SERVICE BULLETIN M20-292A

Date: December 22, 2006

SUBJECT: ENGINE MOUNT INSTALLATION AT FIREWALL

Figure SB M20-292-1

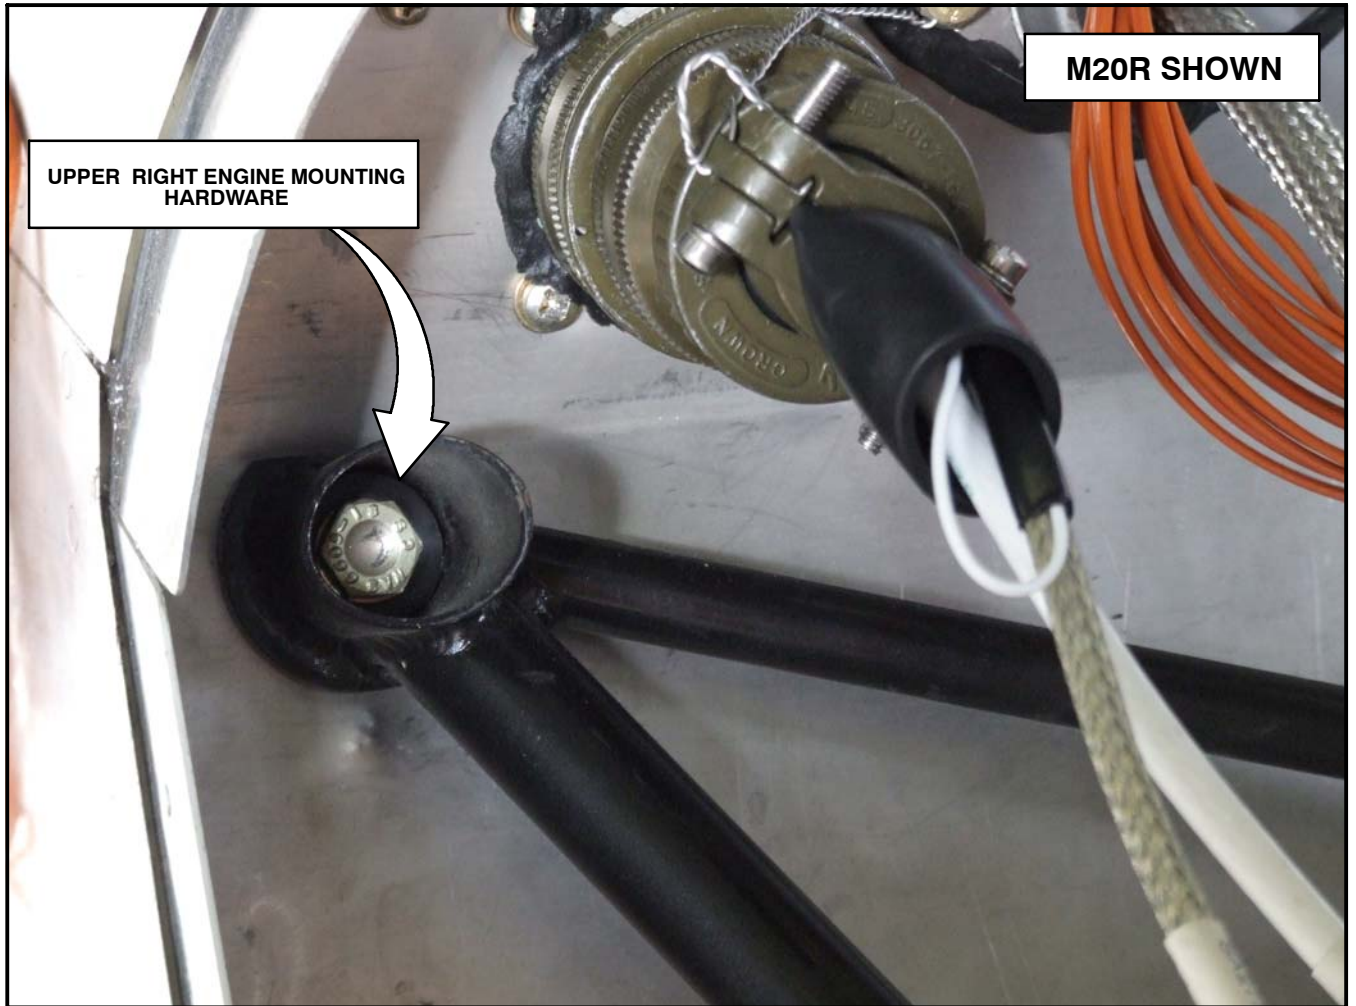
1. Turn master switch - OFF.
2. Remove upper cowling.
3. Locate and retorque upper left and upper right engine mounting hardware (ref. Figures M20-292-1 & M20-292-2):

NAS6604-18 Torque 50-70 inch lbs.*

NAS6605-18 Torque 100-140 inch lbs.*

NAS6605-18 Torque 100-140 inch lbs.*

Figure SB M20-292-5

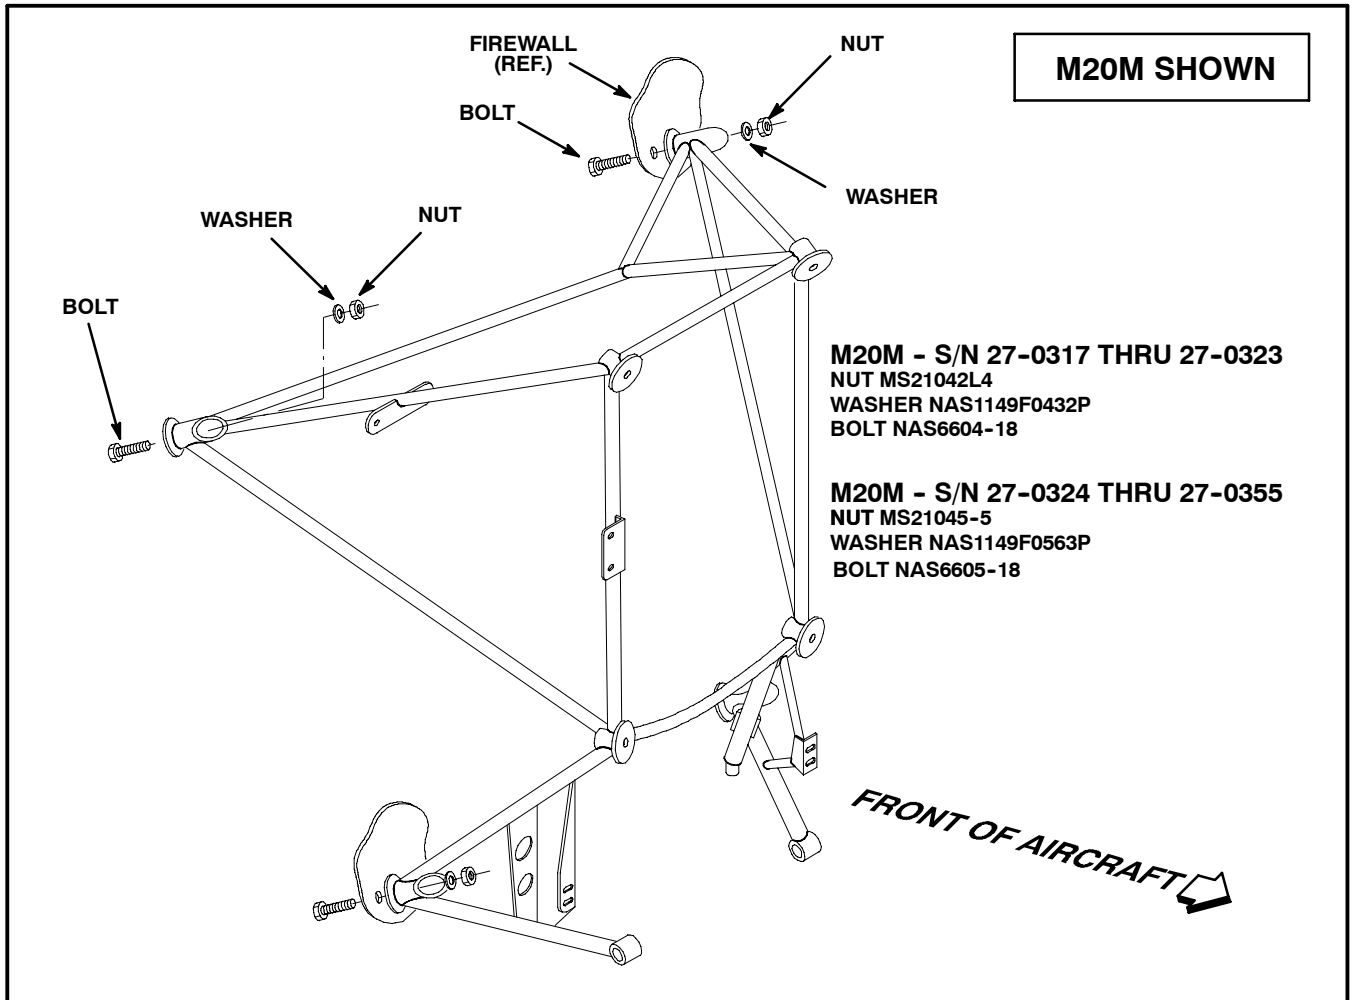
13. Replace attaching hardware with hardware provided in service bulletin kit applicable to the aircraft model/serial number being serviced. Reference Figures M20-292-5 and M20-292-6 for hardware stack-up.

14. Torque upper left and upper right engine mounting hardware (ref. Figures M20-292-5 & M20-292-6):

NAS6604-18 Torque 50-70 inch lbs.*

NAS6605-18 Torque 100-140 inch lbs.*

NAS6605-18 Torque 100-140 inch lbs.*
